**IN KAPITI COAST DISTRICT COUNCIL PROPOSED DISTRICT PLAN  
HEARINGS**

Natural Hazard identification at 8 Tangahoe  
Street Paekakariki

**BRIEF OF EVIDENCE OF DARCY VAUGHAN BRITTLIFF ON BEHALF  
OF KERRY DALTON**

18 July 2016

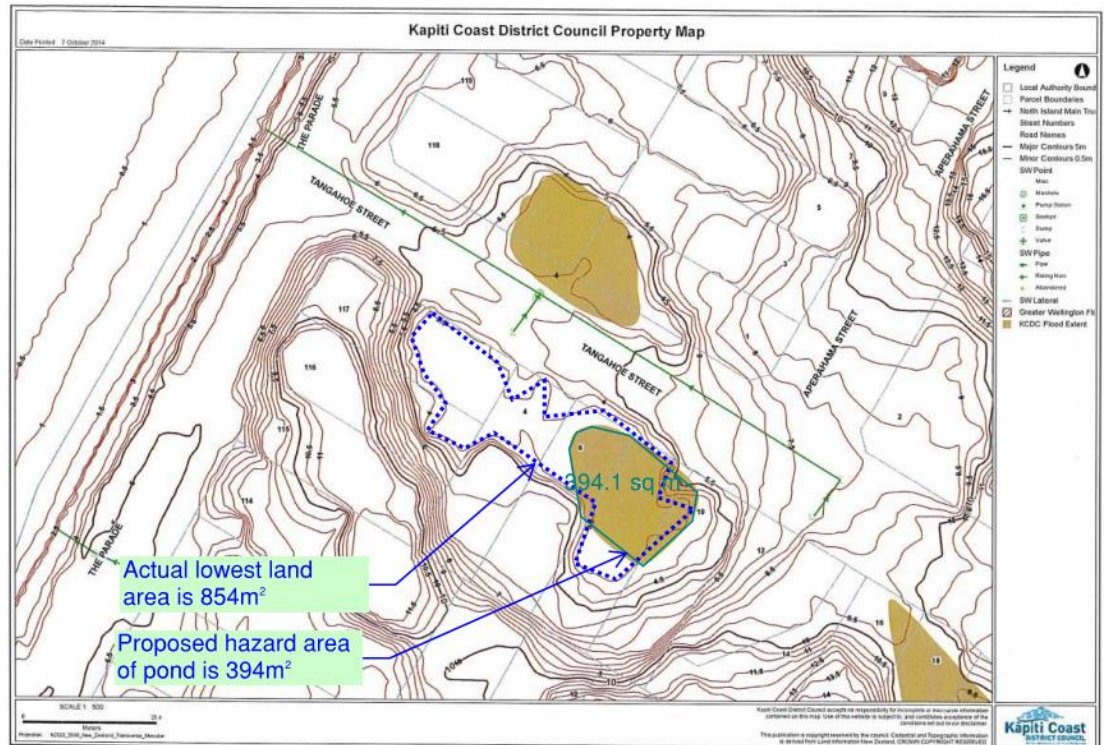
11.10 Evaluation of the area of the proposed ponding shown in the appendix of the Beca report is shown in the following figure. The area of the supposed ponding is around 394m<sup>2</sup>. At a 0.1m depth this equates to 39m<sup>3</sup> of water without any soakage or loss to ground.

11.11 As stated in the Beca report and observed by me on the ground the lower land is actually larger than depicted in the model and is indicated by the dotted area on the figure which I estimate at 854m<sup>2</sup>. For the same 39m<sup>3</sup> volume of water to sit on this land the depth would be reduced as the area is larger and mathematically this is a depth of 45mm.

11.13 We can conclude from that information that if water was to overtop the kerb and enter the land, and that conservatively allowing for climate change and nil disposal via soakage, from the model an anticipated pond in the order of 39m<sup>3</sup> would form. Which I assess as

around a 45mm water depth across the low land. In reality soakage would occur at some rate which would mean that this water depth would be less than this assessment.

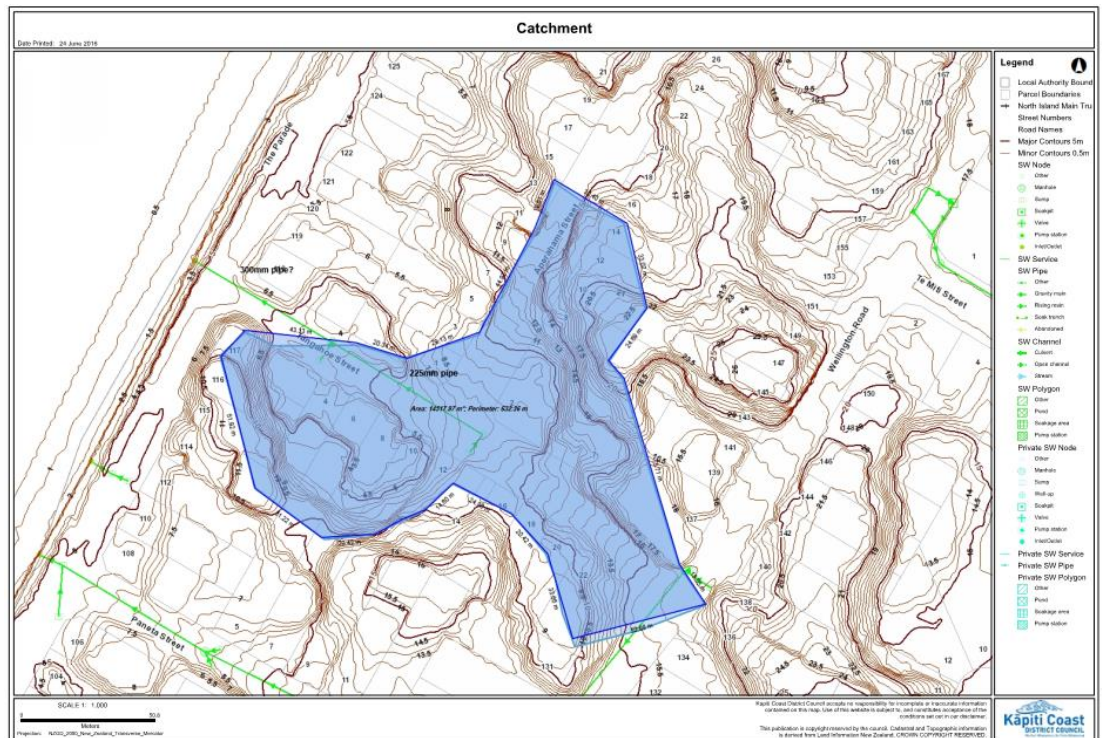
12. I have walked the catchment to review the current location of intakes to the primary stormwater system and to consider any potential cross catchment runoff routes and secondary overland flow routes. With that information I can then form an opinion on potential mitigation options and provide an opinion on risk.
13. The catchment that I have identified is shown on the following figure which is a total of 1.45 hectares.

14. The catchment includes approximately a mix of 1/3 residential land and 2/3 Council road. All of which directs to Tangahoe Street where it is collected in 4 intake sumps before discharge to the sea on The Parade.

15. The primary stormwater system was installed in 1965 and is a 225mm and 300mm pipe connecting the 4 sumps in Tangahoe Street. There is no doubt that in a modern design assessment this primary system would be under capacity in the sense of number of intakes and also potentially pipe size based on today's consideration of design rainfall and outlet water level conditions that accommodate for climate change.

Potential Tangahoe Street improvement  
Not to Scale

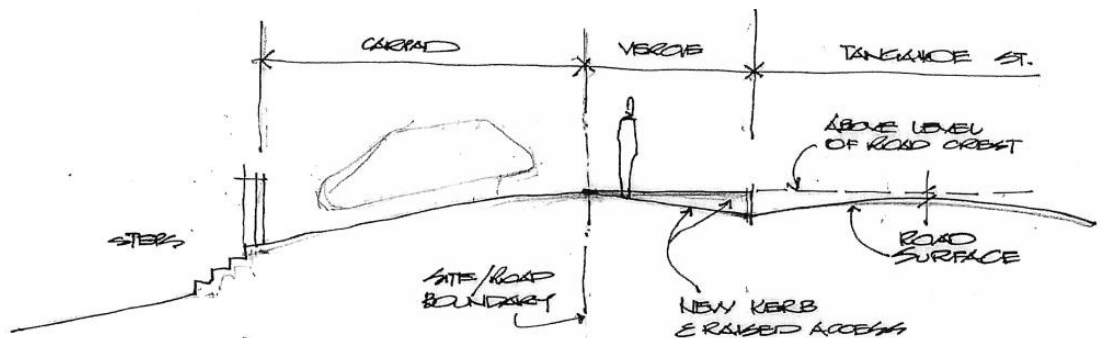
22. Using my values you can consider a broad assessment that Beca are correct and that the flow depth is unlikely to overtop the kerb as the flow is expected to be around 60L/s and the kerb can contain around 70-80L/s. The issue is direct routes from the kerb to the low area and these exist in the form of vehicle crossings and driveways particularly that at 117 The Parade.

23. On inspections of the kerb and berm detail, a simplified improvement could be made in the absence of upgrading any stormwater reticulation. The improvement consists of establishing a defined berm through cutting the road along the southern kerb to create high entry points to the low land relative to any flow by reforming the berm and kerb as per the below figure:

24. The work required to create this formation is minimal and only needs to occur from 8 Tangahoe Street through and beyond the driveway to 117 The Parade which is on Tangahoe Street, some 50 metres.

27. The catchment does however exhibit a low driveway at 4 Tangahoe Street that could be improved by way of a 50 metre berm improvement to further eliminate the risk of direct road runoff entering these properties.
